SERVICE INSTRUCTION

RUNNING MODIFICATIONS ON

ROTAX® ENGINE TYPE 912/914 (SERIES)

SI-912-020R6

fig. 3

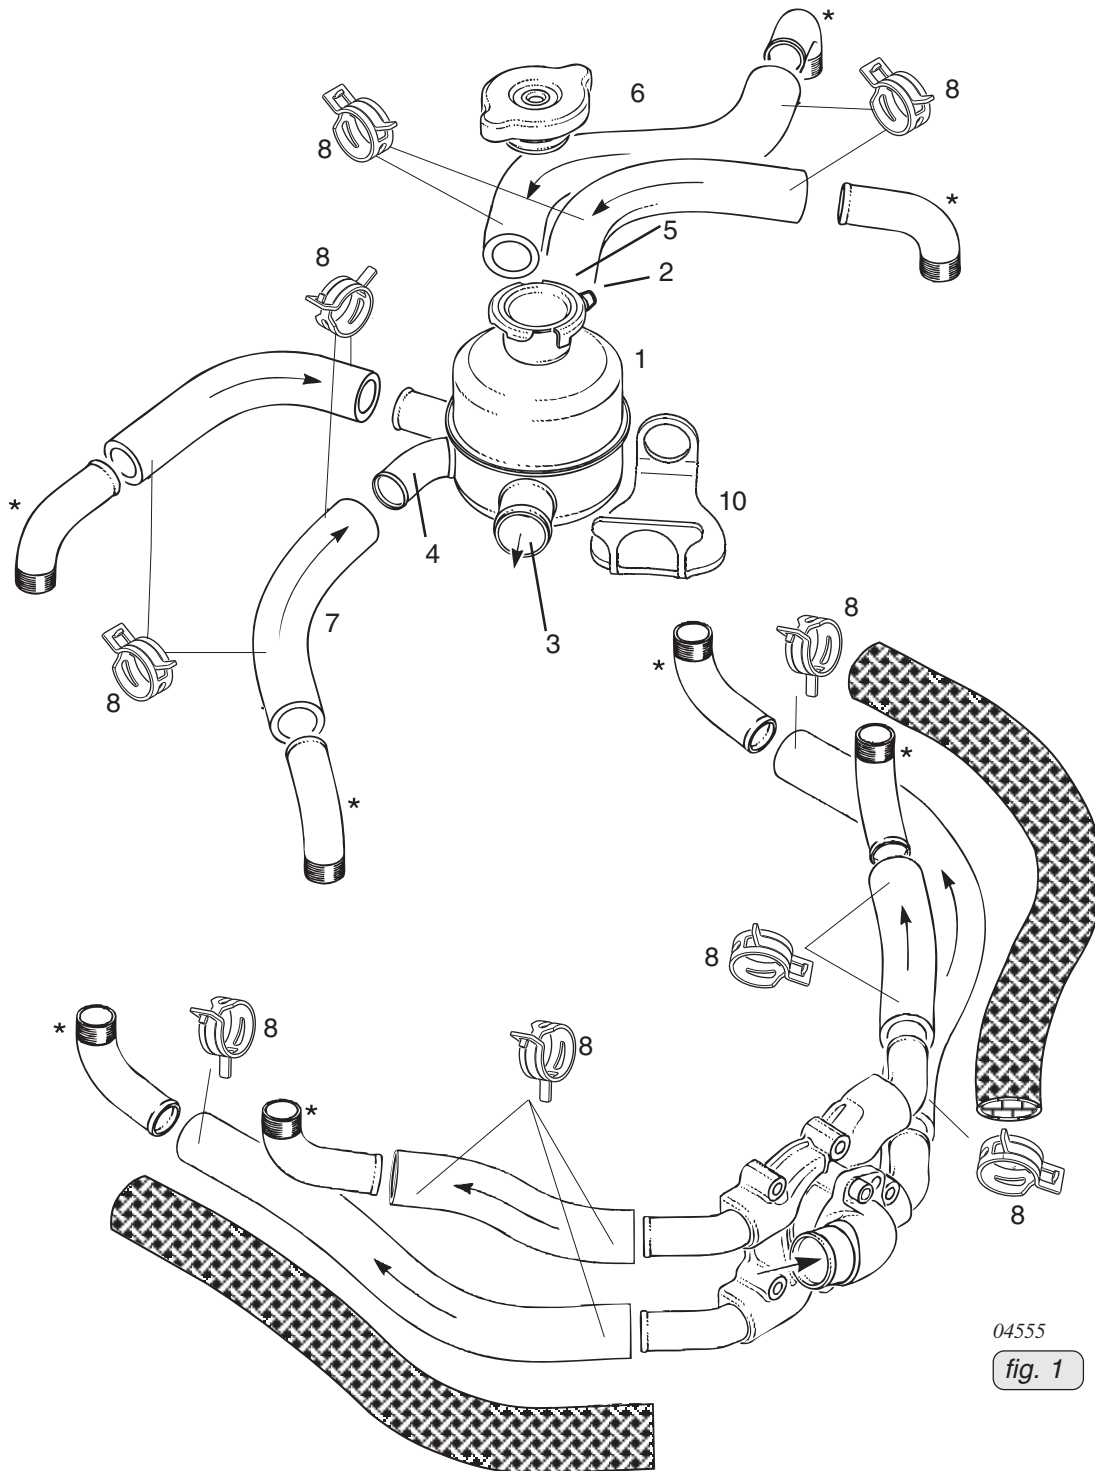
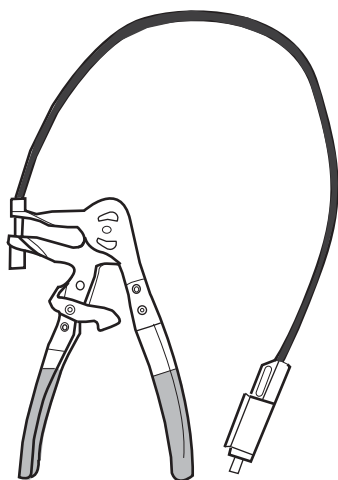
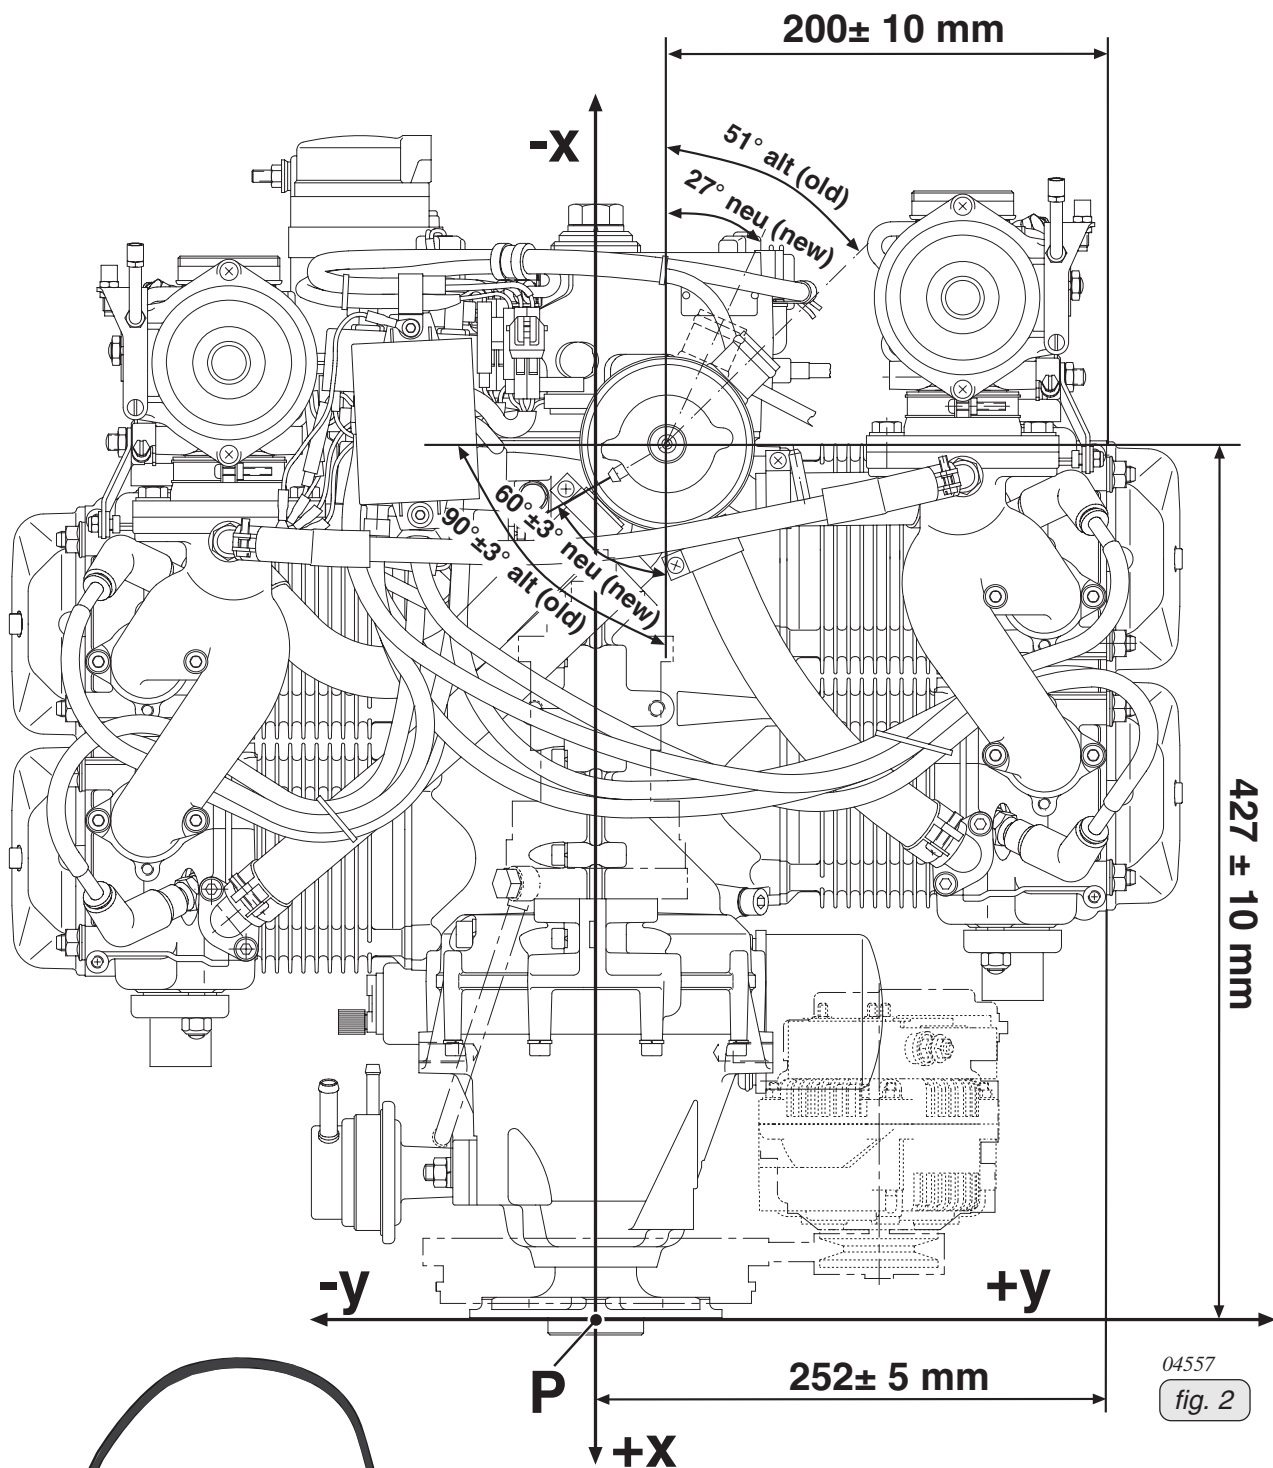
In the course of further development and standardization the position of the expansion tank (1) has been optimized!

- position of connection (2) to overflow bottle (from 0° to 30±3°)
- position of connection (3) to radiator (from 51° to 27±3°)
- angle of inlet socket (4) from cylinder 4 (34° inclined)
- length of inlet socket (5) from cylinder 3 (length increased by 13,4±3 mm)
- length of coolant hose (6) from cylinder 1 (length increased from 270 mm to 285 mm)
- length of coolant hose (7) from cylinder 4 (shortened from 100 mm to 85 mm)
- new spring type hose clamps (8) to attach the coolant hoses (expansion tank and water pump)

- Install the coolant hose (6) 285 mm to cylinder 1 and the new coolant hose (7) 85 mm to cylinder 4. For attaching all the coolant hoses from expansion tank, water pump, cylinders, use the new spring type clamps.

■ **CAUTION:** Take care of appropriate slip-on length of the coolant hoses on the corresponding connection socket. Verify tight fit of clamps and hoses and check for leakage. Always fit the clamps such that they can not wear on any component and use a suitable tool (see fig. 3) for fitting them.

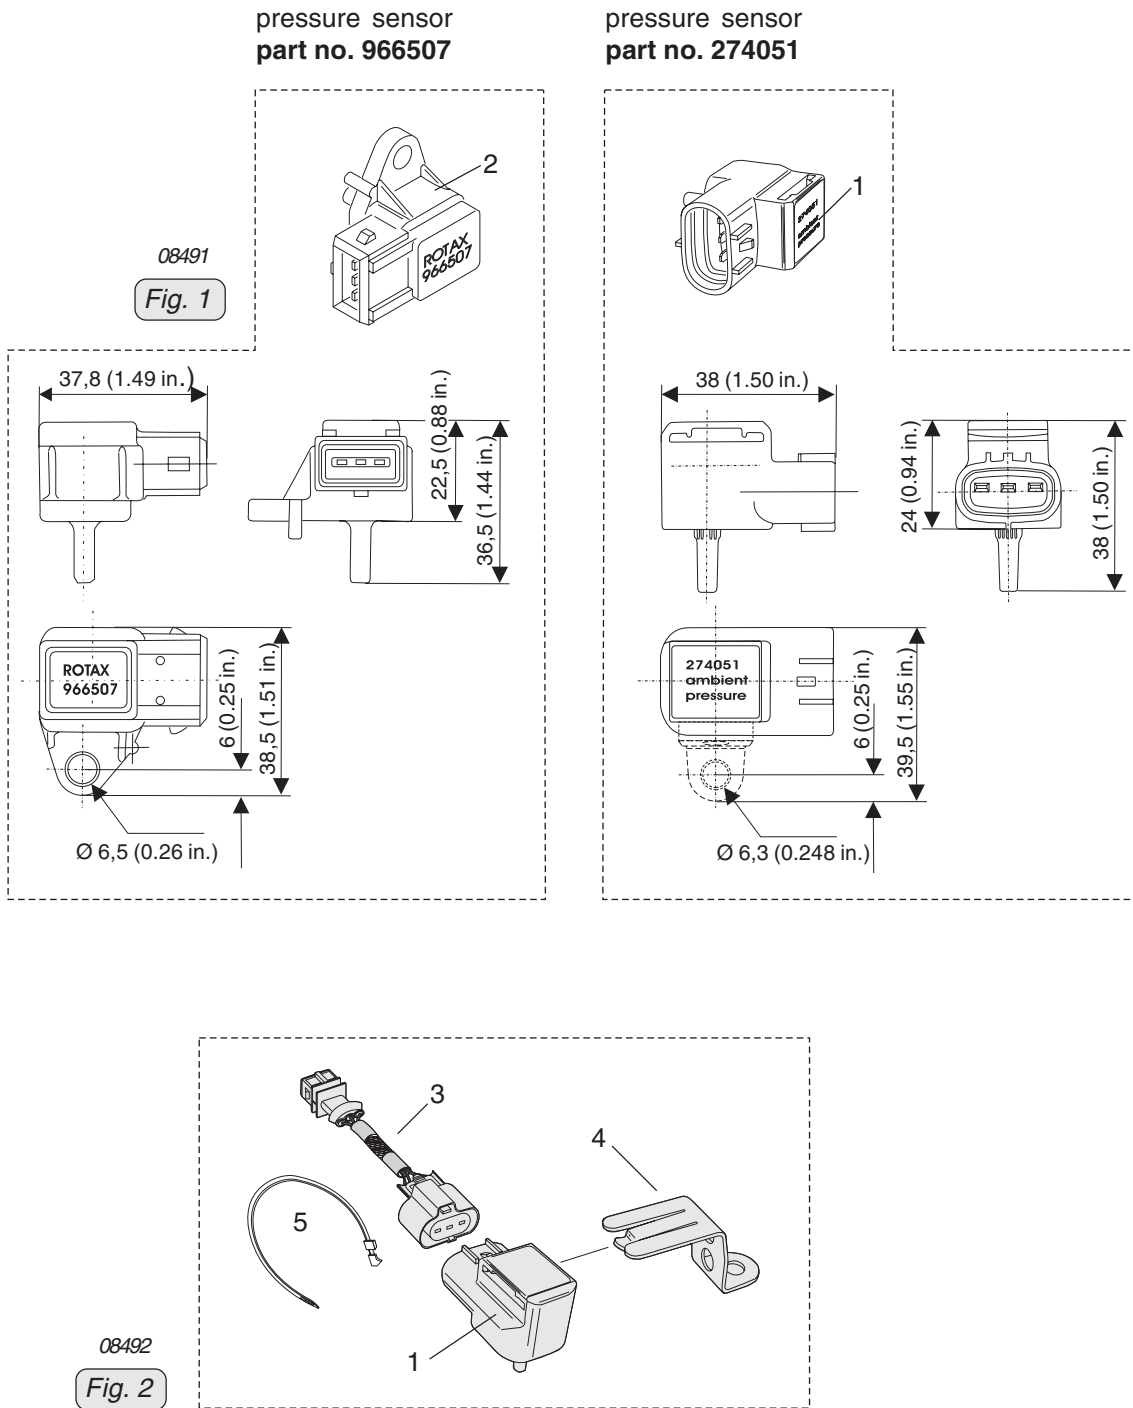
Due to the termination of production of the ambient pressure sensor (part no. 966507) a new ambient pressure sensor part no. 274051 has been introduced. The new ambient pressure sensor is of different size and also has a different connector. The connection for the wiring harness had to be changed.

1. Disconnect the pressure sensor (2) from the wiring harness.
2. Connect adapter cable (3) to wiring harness and to the new pressure sensor (1).
3. Install bracket (4) onto pressure sensor.

■ CAUTION: Route all wiring as such that there will be no sharp bends or chafing.
4. Position adapter cable and secure with cable binders (5).

new Version

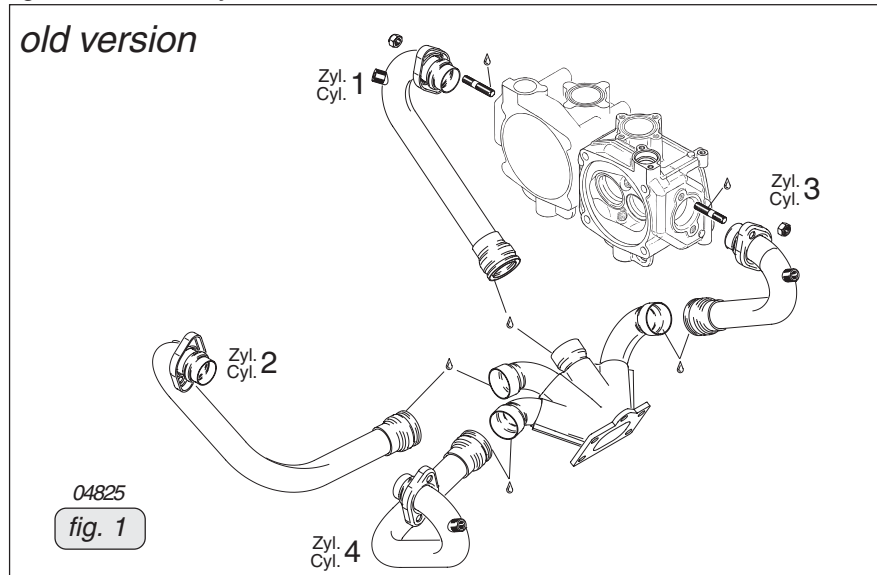
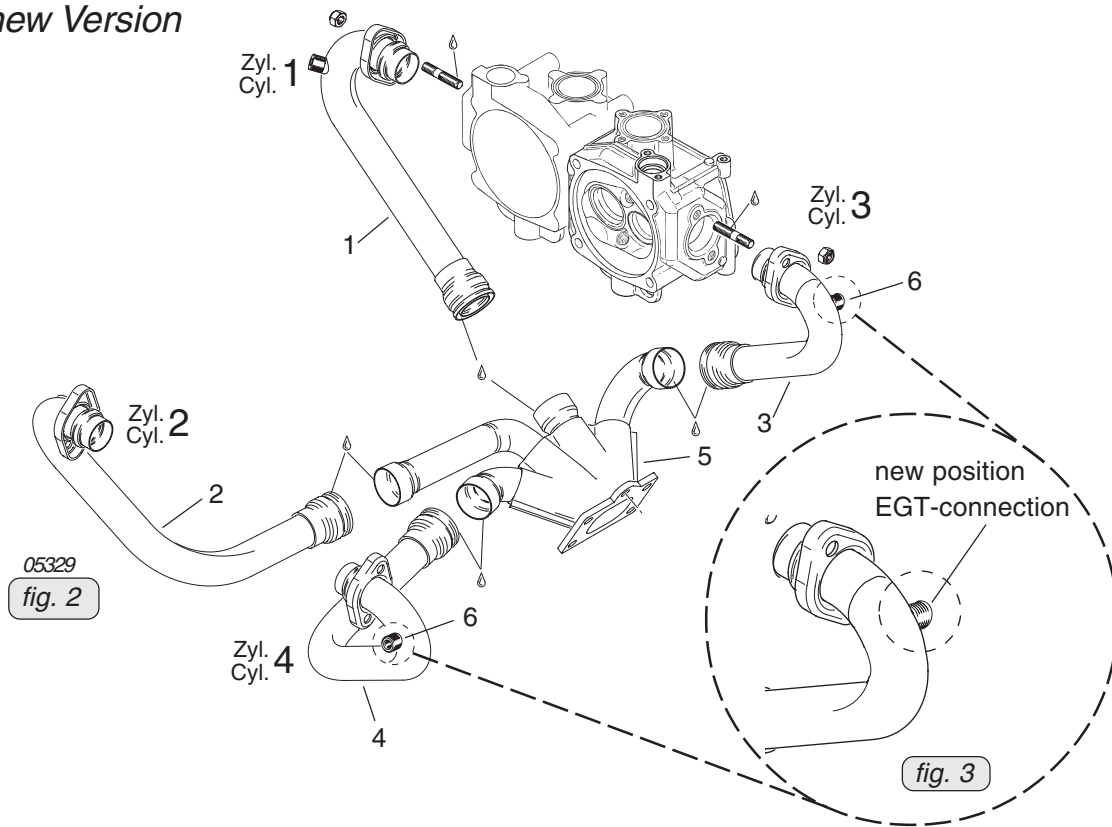
Owing to continuous further development, the exhaust bends were slightly re-worked. The couplings were optimized for their position.

- Position of the EGT connections (6) to the exhaust bends for cylinders 3 and 4 were routed such that installation of the new drip trays is possible.

fig. 3
06394

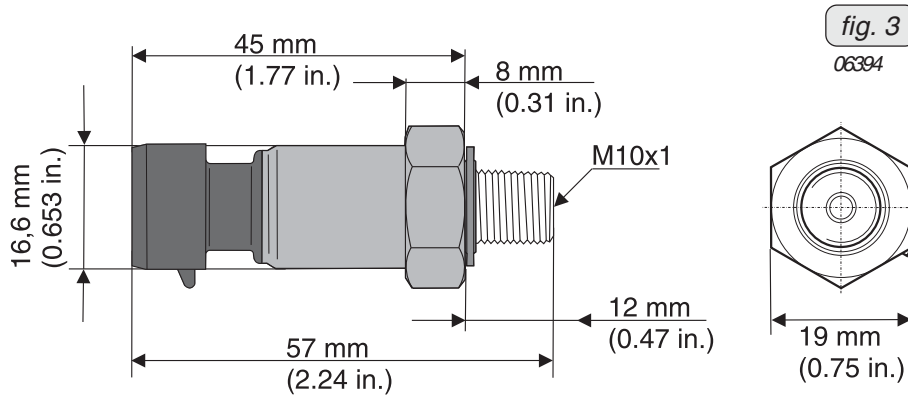
In contrary to the oil pressure sensor part no. 956413 the new oil pressure sensor part no. 456180 is equipped with a connector. As output signal the 2-wire version (4 to 20 mA) is available. **Oil pressure sensor PIN A** (connector housing PIN 1) is not connected and has no function.
